# ASP General Information Service & Installation Compliance

Alert Number: GI22\_22

## Subject: Electrical Safety Rules (ESR) Clarification – Appendix A Live Low Voltage Task List Commercial Pillars.

### Amendment to Appendix A

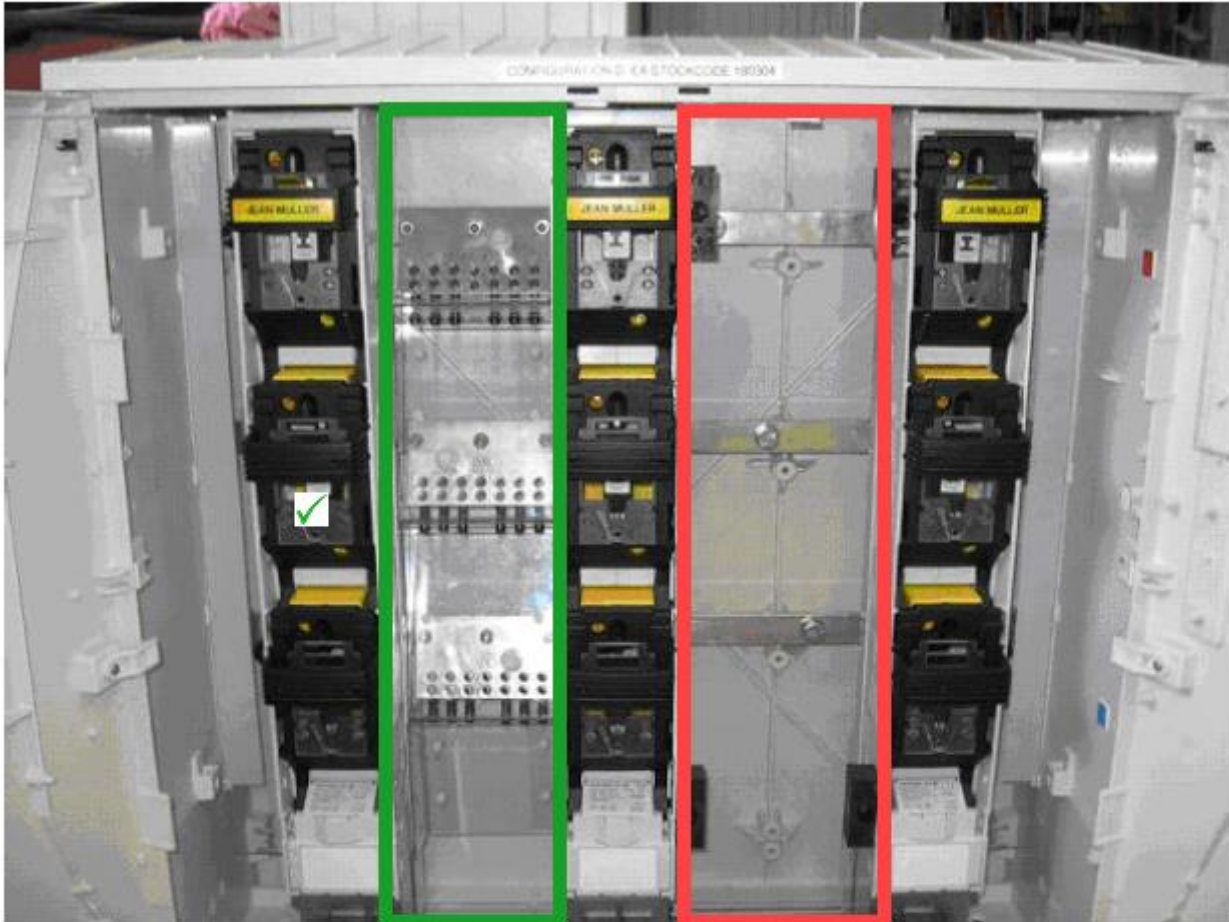
The Electrical Safety Rules (ESR) Appendix A – Live Low Voltage Task List, has been updated, with the latest edition being dated 06/10/22. This latest update included changes to the allowable tasks on Commercial Pillars that are compliant with Network Standard NS224.

#### Appendix A now allows

The “100/200A - Yes” is intended to mean that service (or street lighting) cables, which are to be connected to the service terminal blocks within a commercial pillar (generally 100A or 200A services) may be connected with the mains remaining energised. This is allowed because the service terminal blocks are screened individually and there is no need to remove any screening or apply any temporary insulation to any exposed conductors to facilitate the connection of the cables.

The “>200A - No” is intended to mean that cables, which are too large to fit the service terminal blocks and are to be bolted to the busbar (generally services greater than 200A) may not be connected while the busbar is energised. This is because the removal of the screen over the busbars exposes all three phases and there is no ready means of applying temporary insulation to the busbars.

✓ Services may be connected to energised terminal blocks

✗ Services must not be connected to energised busbar  
**Outage required**
